Subject: Oconee Nuclear Station
Docket Nos. 50-269, -270, -287
Oconee Reload Design Methodology Technical Report

OCONEE RELOAD DESIGN METHODOLOGY
TECHNICAL REPORT

RESPONSES TO NRC QUESTIONS
OF
OCTOBER 16, 1980

Figure 4-1. (FSAR Figure 14-1)

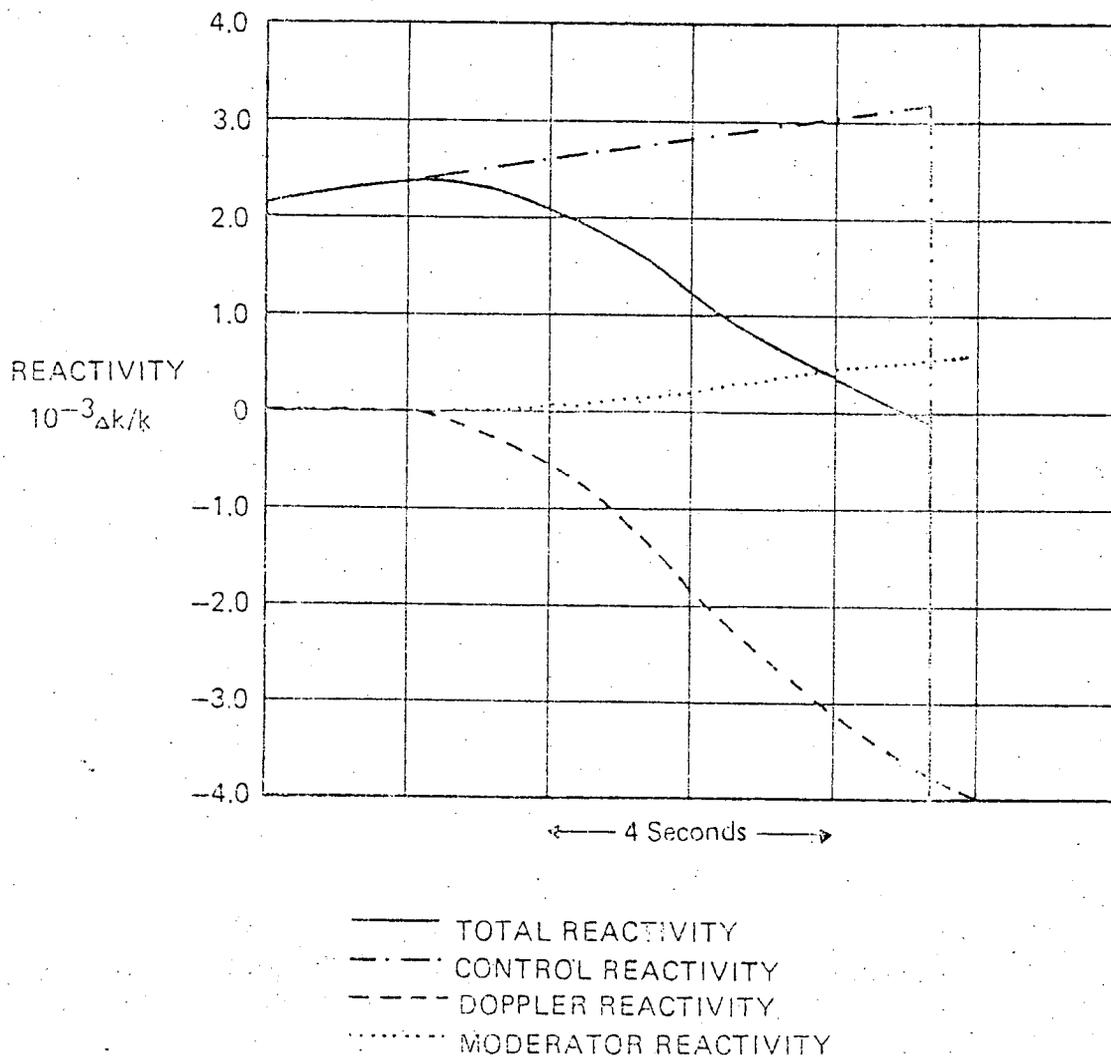
Give the variation of the total (and its components) reactivity for the start-up accident for the first 10 seconds after the accident initiation, (these would complement Fig. 14-1 and 14-2 of the Oconee FSAR Rev 16).

- A. 4. The variation of the total reactivity during a start-up accident is the sum of three reactivity effects. The withdrawal of the control rod banks adds positive reactivity which causes the neutron power level to increase and raise the average core temperature. The increase in fuel temperature causes a negative reactivity feedback due to the negative Doppler coefficient. The increase in power level increases heat transfer from the fuel to the coolant, resulting in an increase in moderator temperature. This causes a positive reactivity feedback since a positive beginning of cycle moderator coefficient is assumed. The transient response is primarily determined by the rate of positive reactivity addition from the withdrawal of rods, and the Doppler feedback which slows or terminates the nuclear excursion. The moderator feedback has a smaller effect.

The reactivity response of the startup accident simulation performed by B&W and used in the original FSAR analysis is not available. In order to respond to the question, the variation of the total reactivity and its components were back-calculated from the results presented in FSAR Figures 14-1 and 14-2, utilizing the analysis assumptions specified in the FSAR. Using this method, the trends of the parameters of interest can be determined with a reasonable degree of accuracy. Figures 4-1 and 4-2 show the variation of the reactivity consistent with FSAR Figures 14-1 and 14-2 respectively. It should be noted that these figures do not represent the first 10 seconds of the transients, considering that the initial conditions are $10E-9$ rated power and 1% k/k subcritical. Figures 4-1 and 4-2 illustrate the time interval of greatest interest during the transient, Figure 4-1 is the same scale as Figure 14-1, and Figure 4-2 is the first one second of the response in Figure 14-2. For both transients the reactivity addition for the first 10 seconds following initiation of rod withdrawal would only cause a reduction in the subcriticality margin.

Figure 5-1 (FSAR Figure 14-9)

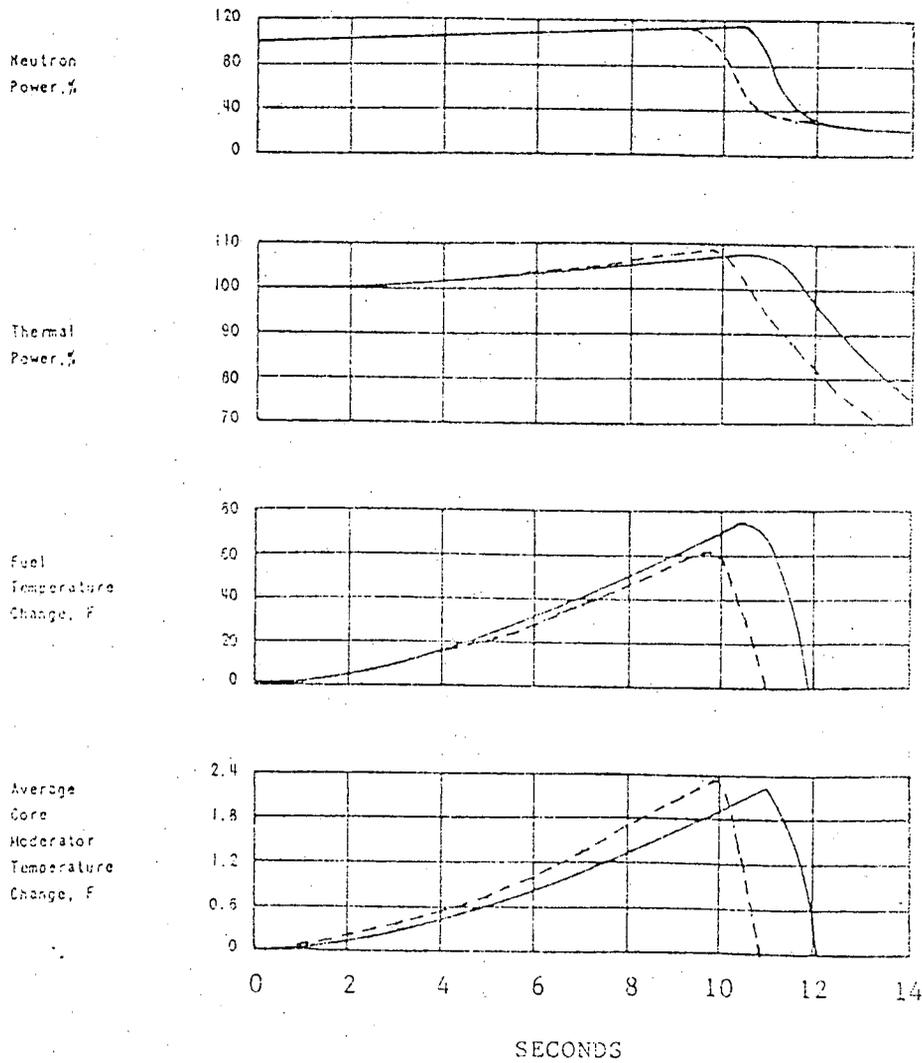
Give the variation of the reactivity as in 4. above.

A. 5. The reactivity response of the rod withdrawal accident at rated power simulation performed by B&W and used in the original FSAR analysis is not available. In order to respond to the question a similar analysis was performed by Duke Power Company using the RETRAN code and matching as accurately as possible the modeling assumptions of the original analysis. Figure 5-1, a revised FSAR Figure 14-9, shows the comparison between the original analysis (solid lines) and the new analysis (dashed lines). No attempt was made to match the results of the original analysis, the intent being to match the assumptions and initial conditions. The similarity between the results of the two analyses supports the conclusion that the reactivity response of the new analysis shown in Figure 5-2 is representative of the original analysis.
